**Regional Citizens' Advisory Council** / "Citizens promoting environmentally safe operation of the Alyeska terminal and associated tankers."

During May of 2006, a concerned citizen requested that Prince William Sound Regional Citizens' Advisory Council (PWSRCAC) make inquiry into specified and unspecified reports from other concerned individuals pertaining to the integrity of tank welds whose failure was alleged to have the potential for producing a "tsunami of oil" in Port Valdez. The VMT Systems Integrity project was created in July 2006 to examine integrity issues associated with the reports and to ensure that any identified integrity issues do not pose an increased risk for spillage of oil.

- (a) "Contract 505.2007.01 – VMT System Integrity Issues Summary of Harvey Consulting Finding of Facts, Allegations, and Recommendations," dated April 5, 2007.

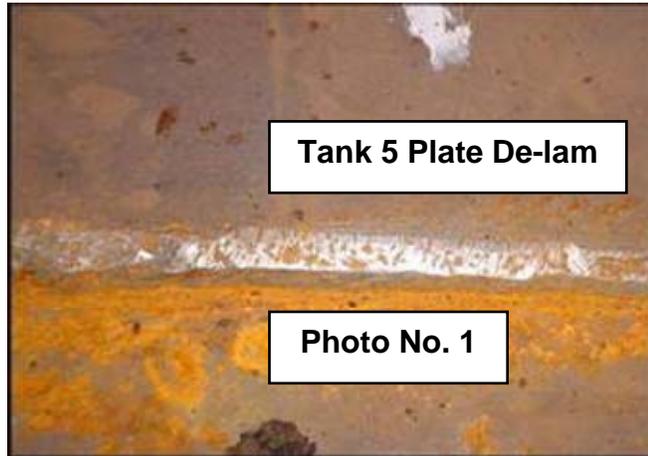
### **Allegation No. 3 – Floor Material Quality**

**Concern:** “Plate lamination.<sup>19</sup> Many of the plates used for the floor had lamination. No NDE [nondestructive examination] was done to determine the extent of the flaw. No assessment was done. The areas were just "ground out." This does not satisfy API 653-2.3.6.”

**ADEC Finding:** “API 653-2.3.6 is only for shell course lamination. No section of API 653 can be found relating to **FLOOR** plates lamination.”

**Analysis:** ADEC restricts their analysis to the specific language of API 653, Section 2.3.6, but does not answer the more important questions: (1) were there defects in the material used to repair the tank floors, and (2) could the use of poor quality material increase the oil spill risk? Several people interviewed for this report are still concerned poor quality metal was used to replace the Tank 5 floor. It is alleged that laminations in the floor plates were found and ground out. Some amount of “patch” welding was completed to repair the more serious laminations. It is alleged that repaired areas of the new floor were not tested to ensure adequate thickness and integrity prior to returning Tank 5 to service; however, APSC disputes this claim.

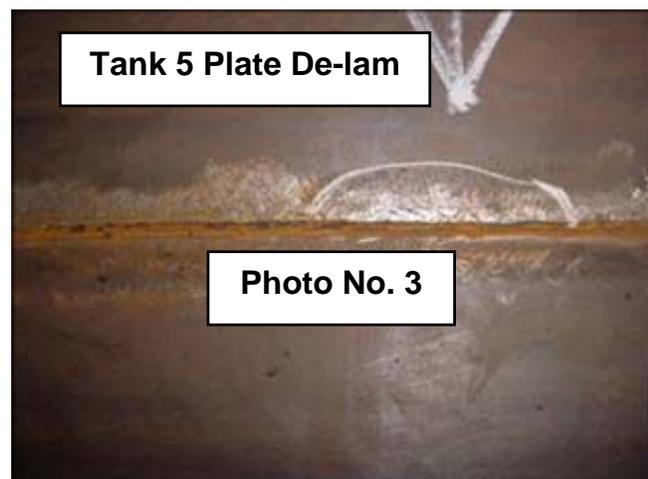
**Records:** API Inspector Lane's August 24, 2002 API 653 report concluded:

*A total of 84 plates showed areas of delaminations. Sketches of floor plates in question [were] drawn up and submitted to engineering for follow up.*
